ITEM 10 – HIGH SPEED RAIL (HS2) PHASE 2: CONSULTATION IN RESPECT OF PROPOSED ROUTE FROM WEST MIDLANDS TO LEEDS – RESPONSE OF NORTH WEST LEICESTERSHIRE DISTRICT COUNCIL

RESPONSE FROM PACKINGTON NOOK RESIDENTS' ASSOCIATION

HS2 Phase 2 Consultation Response on behalf of Packington Nook Residents' Association

January 2014

HS2 Alternative Route HSL08 (Birchmoor to Tonge)
Showing section between Twycross and Newbold
Promoted by Packington Nook Residents' Association
Taken from HS2-ARO-000-RP-RW-00007

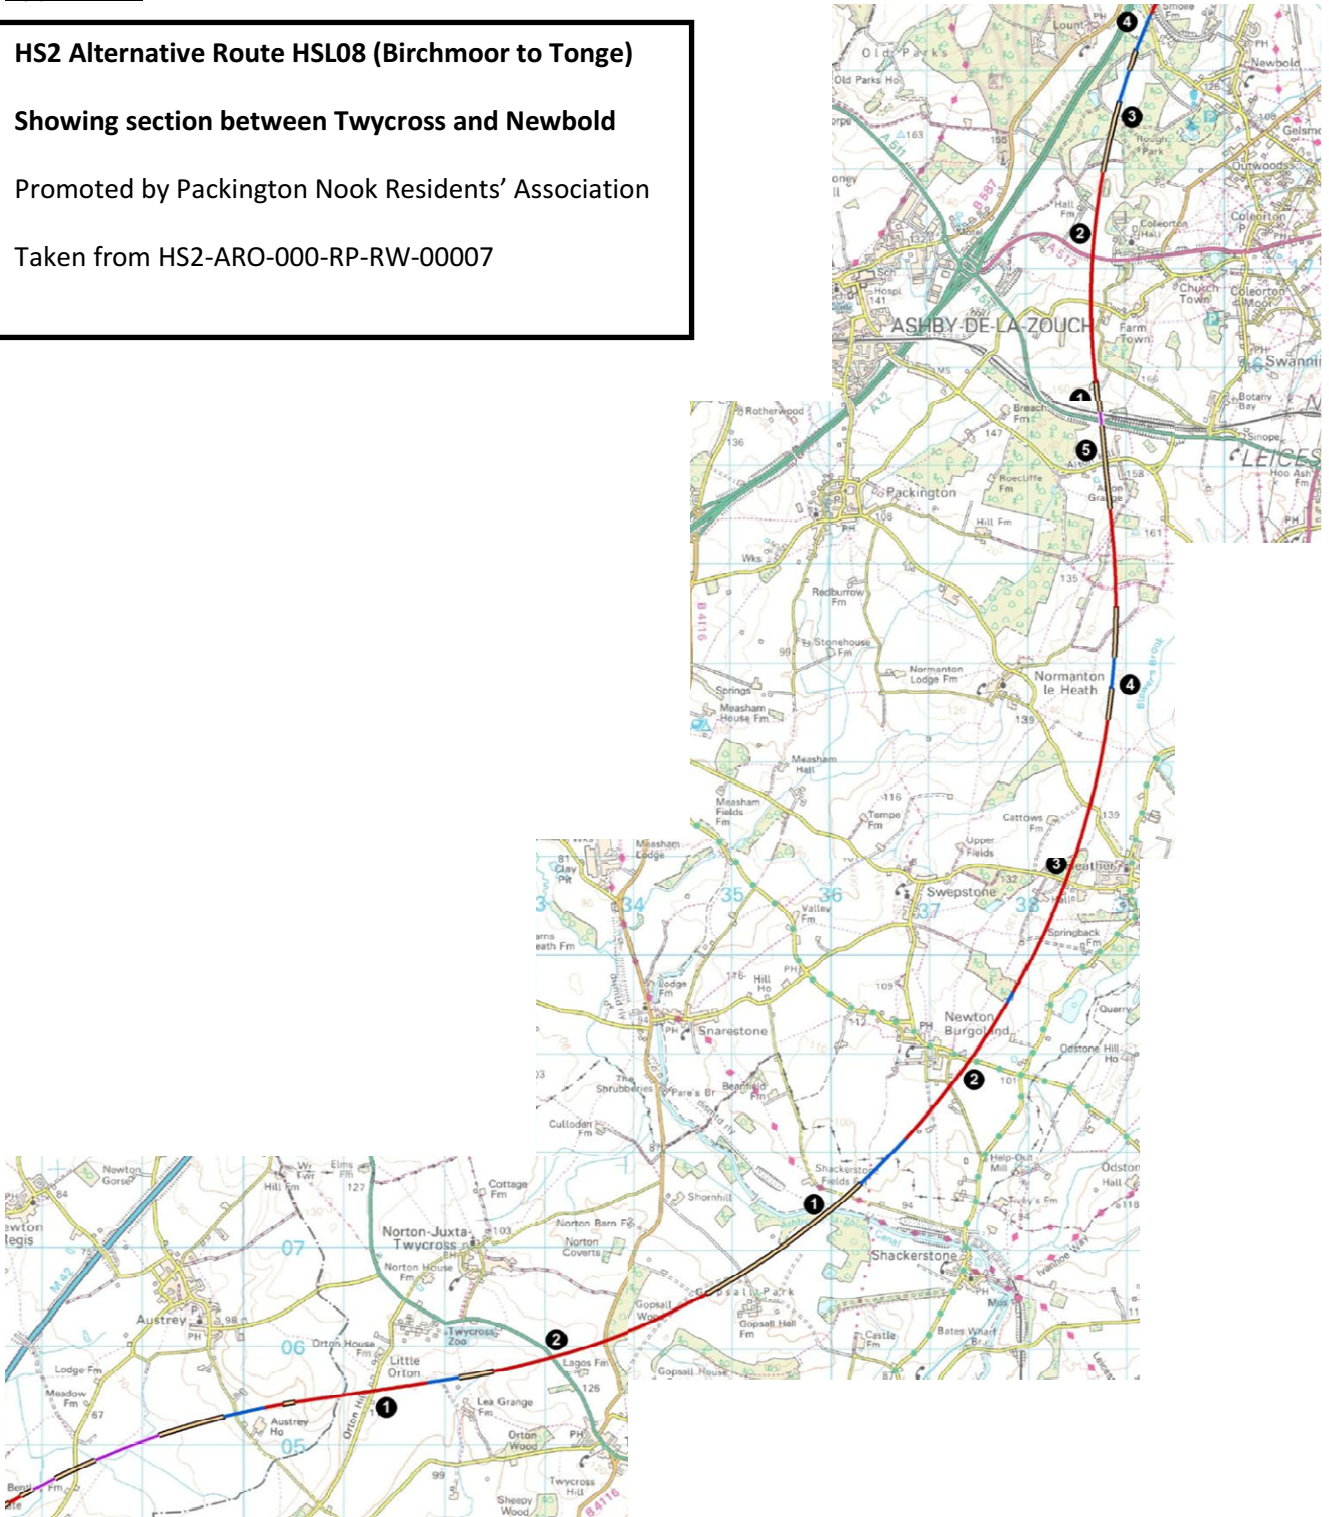
The alternative route HSL08 - Birchmoor (B) to Tonge via Twycross (G) - shown in the initial HS2 Engineering Options Report (HS2-ARP-000RP-RW-007 March 2012) [*Appendix 1 of this response*] distances most of the major habitations on this section and avoids having to realign the A42 and reduce junction remodelling described in paragraph 8.2.1. For much of its length it would cross land previously used for opencast extraction and of limited landscape value.

The alternative HSL08 route appears to have been overlooked in favour of a route that may give marginal advantage on limited criteria.

Therefore we submit that there is no proper comparison of the total effects of the proposed HSL06 route compared with the alternative HSL08, including the total effects on residents.
